Title: Applicant Response to Hertfordshire
County Council LLFA Consultation
Response

Date: 25th July 2024

- 1.2 A planning application (Reference: 3/24/0966/OUT) was submitted for the following:
- "Outline planning application for development of up to 600 dwellings (C3), elderly accommodation (C3), Mixed Use Local Centre (including flexible use E, F and Sui Generis), First School, informal and formal open space, associated works and infrastructure including a new access from the A507 and pedestrian bridge over the A10, with all matters reserved except access."*

- 1.5 This technical note provides a formal response to the comments received from HCC LLFA in its consultation response.

TITLE:
FLOW ROUTE REVIEW PLAN

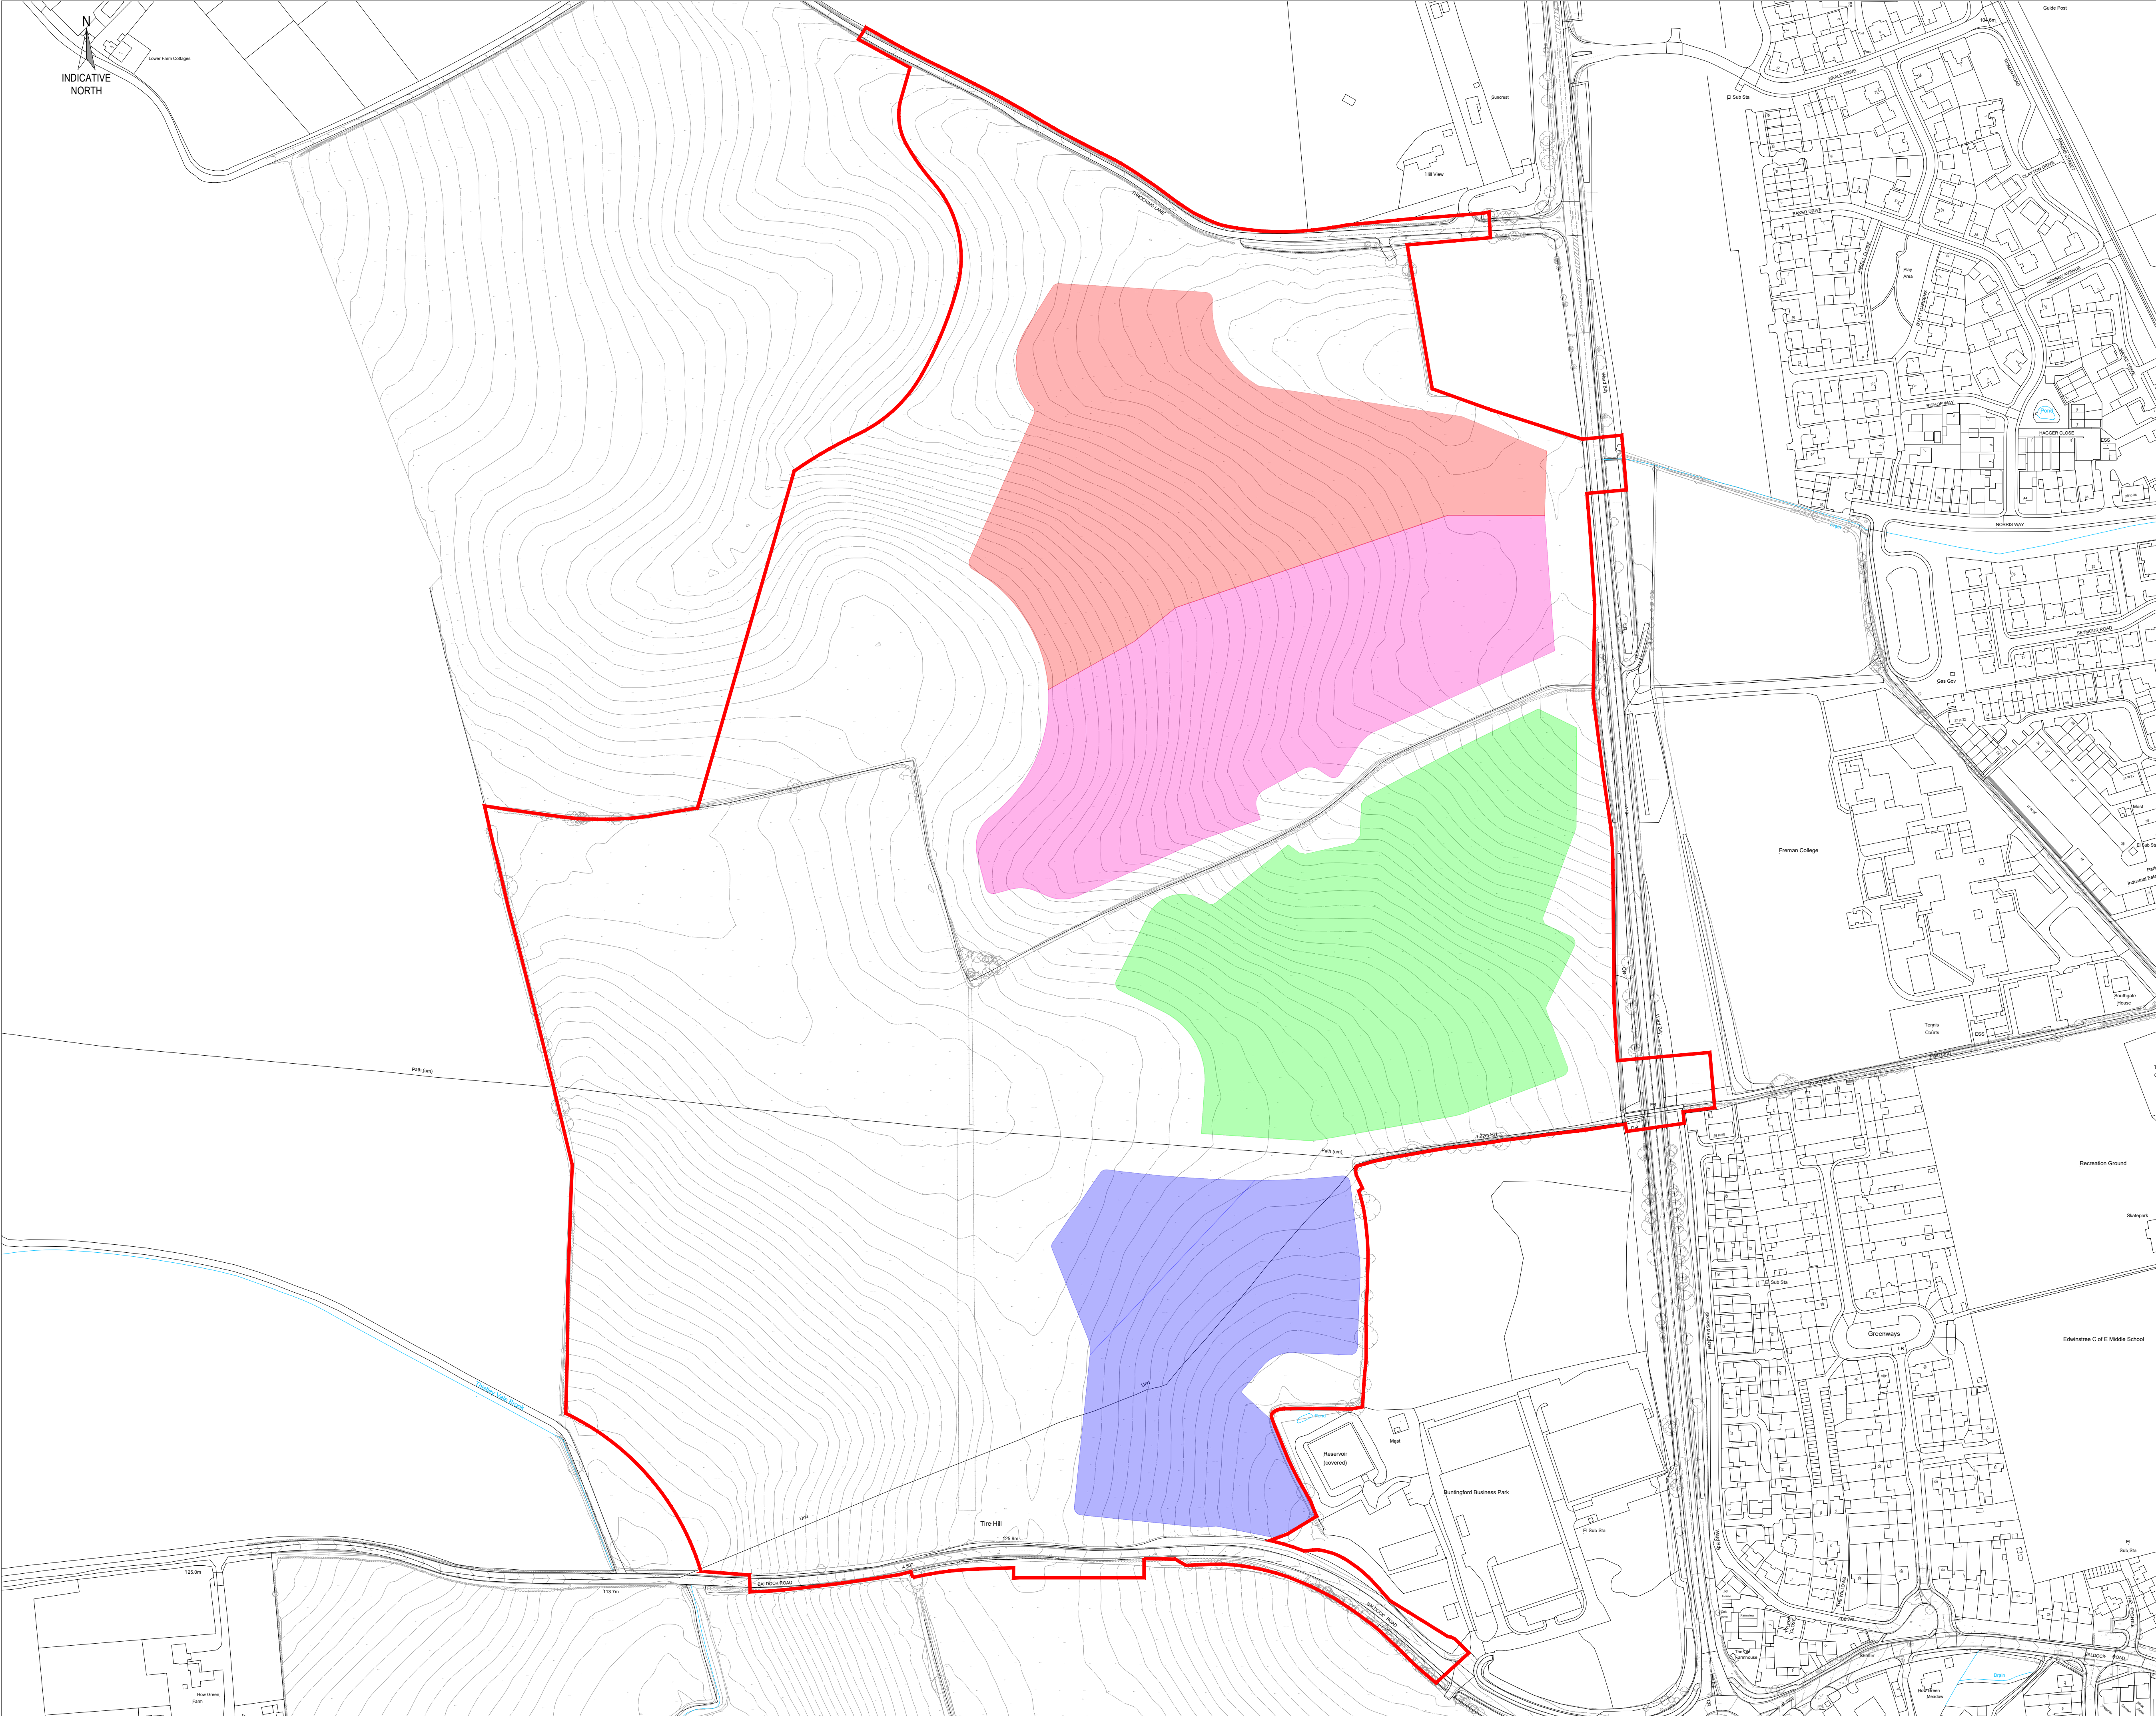
No.	LLFA Comment	Applicant Response
1	OBJECTION Provide updated information within an amended FRA on; Surface water flow path originating offsite. Further information required on the surface water flow paths on the site. Without carrying out further modelling, the EA maps are the best source of data available. We understand that this modelling may not account for some mitigation measures in and around the	As mentioned in the LLFA response, the EA surface water flood maps are the best source of data available showing potential flow routes and areas at risk of flooding. However, the EA state that their mapping is only indicative and does not contain sufficient information for it to be used as sole evidence for any specific planning decision or assessment of risk. We have therefore taken the EA data and undertaken further review and assessment of the site and the surrounding area to determine the actual risk of flooding to the site. Several key factors have been considered to further assess the risk to the site:

No.	LLFA Comment	Applicant Response
	proposed site, however in the absence of detailed modelling the site outline development areas MUST be located outside of the 0.1% AEP outline and any likely road crossings to be indicated to connect development parcels. If the drainage system is to cater for flow paths, the extra volumes must be calculated and included in any outline drainage storage calculations. This may influence the Parameter Plan that would be associated with an outline application and the available space for the number of dwellings indicated with associated infrastructure e.g. road with swales and SuDS attenuation features.	- Upstream Catchment – Levels & Characteristics A detailed review of the existing nature, levels and any drainage features has been undertaken to determine the actual upstream catchment where flows would be conveyed towards the subject site. A plan has been included in Appendix A which shows the upstream catchment extents along with the location of the existing drainage features which have been identified within the area. The area outlined in light blue shows the total upstream catchment taking into account the existing levels and any existing drainage features, with the area outlined in purple showing the area of the upstream catchment where there is known to be existing field drains present. The upstream catchment is relatively small and comprises of fully greenfield land which is currently used for agricultural purposes. BGS maps indicate that the site is underlain with bedrock of the Lewes Nodular & Seaford Chalk formation, with overlying superficial deposits of Lowestoft Formation. The superficial deposits are expected to extend a significant depth beneath the site and consist of chalky til, together with outwash sands and gravels, silts and clays. While this strata is expected to be unsuitable for the discharge of concentrated surface water run-off from the development via large scale point infiltration features, the strata has a mix of characteristics including chalk, sands and gravels, it is therefore considered that this type of strata has an element of permeability which will intercept a proportion of the runoff from the surface. Based on the size, nature and characteristics of the existing upstream catchment it is considered that the generated run-off will be minor and that the EA surface water flow routes are an exaggeration of the actual real-life scenario. - Existing Drainage, Ditches & Field Drains A large amount of existing drainage features are present within the site and the surrounding area, these features have not been taken into account as part of the EA mapping which further highlights the level of detail of the current data.

No.	LLFA Comment	Applicant Response
		The existing drainage features include: i) An existing drainage ditch is present running along the western boundary, before running through the site in an easterly direction. ii) A section of Throcking Lane which bounds the site to the north is positively drained with highways drainage present. iii) The culverting of the existing drainage features within the site beneath the A10 is not taken into account, instead flows are shown backing up into the site due to the levels of the A10. iiii) Most importantly there is a significant network of existing field drains which are present within the site and the adjacent land to the west and north. All these features play a significant role is the interception of overland flows from the neighbouring land which significantly affects the flow paths running across the site. Based on the presence of these features and the nature of the catchment and surrounding area, it is considered that these features will intercept a significant proportion of any overland flows from the neighbouring land. Consequently, it is considered that the flow paths shown on the EA mapping are significantly exaggerated compared to the actual current scenario. Based on the factors discussed above, it is considered that the risk of flooding from overland and surface water sources is low and does not pose a significant risk to the development. Although it is not considered necessary, to further mitigate any residual risk to the site it is proposed to construct an interceptor trench along the western and northern site boundaries as part of the development proposals. This feature will intercept any surplus run-off, with flows conveyed to avoid the development and discharge into the existing watercourse on the eastern boundary, in line with the existing greenfield regime of the site. Based on the further assessment undertaken and the extra mitigation measures proposed, it is considered that the risk to the site is very low and development within these areas shown at risk is appropriate. It is considered that further hydraulic modelling is not necessary to demonstrate the appropriateness of development within these areas as the factors raised above clearly demonstrate that the risk posed is very low.

DRAINAGE CATCHMENT PLAN

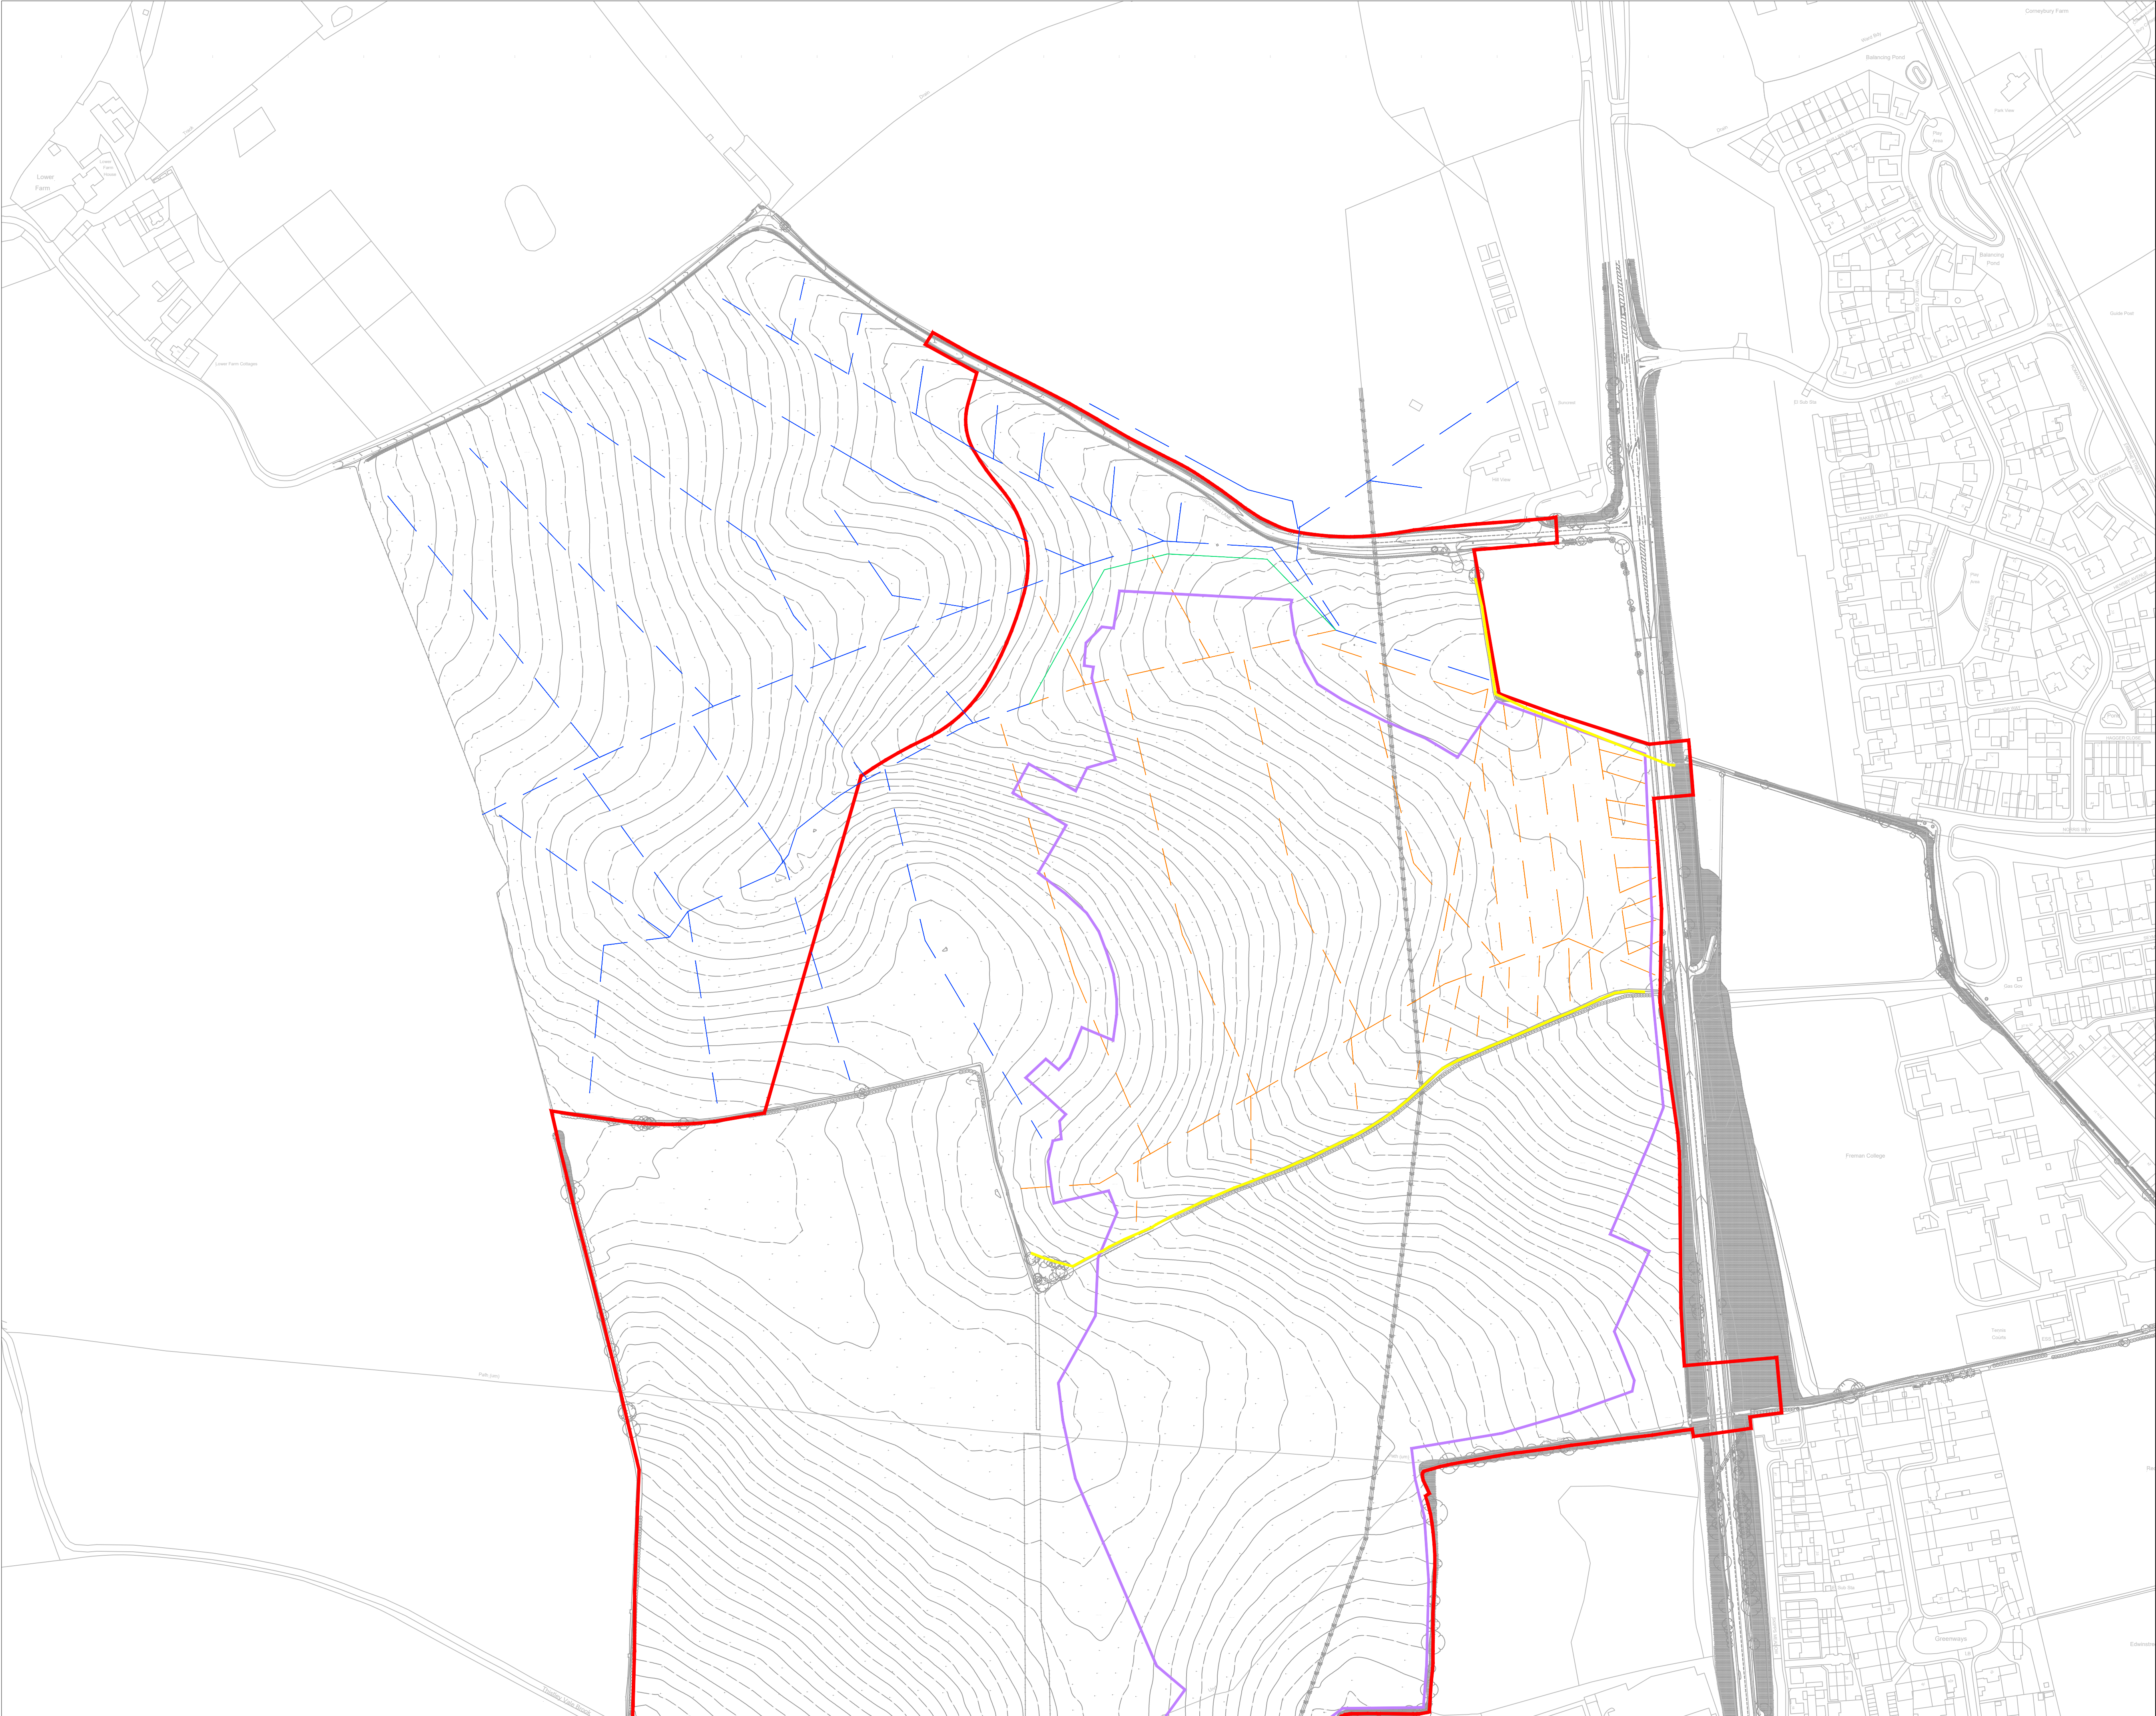
6	OBJECTION Greenfield runoff rates and volumes are missing or need to be recalculated (incorrect input parameters). To enable 'Plan B' to be checked we require catchment plans to go with the calculations provided. We require clarification on the difference catchments used and how the total area for each one has been derived e.g. using topographical information from on site, LIDAR or other sources plus the full hydrological assumptions for each catchment labelled.	The proposed drainage calculations have been based on catchments informed by the onsite topographical survey. The catchments are based on the existing levels with each catchment considered to reflect the current catchments of the greenfield site, to ensure the drainage proposals mimic the existing drainage regime of the site. A drainage catchment plan has been produced and is included in Appendix B.
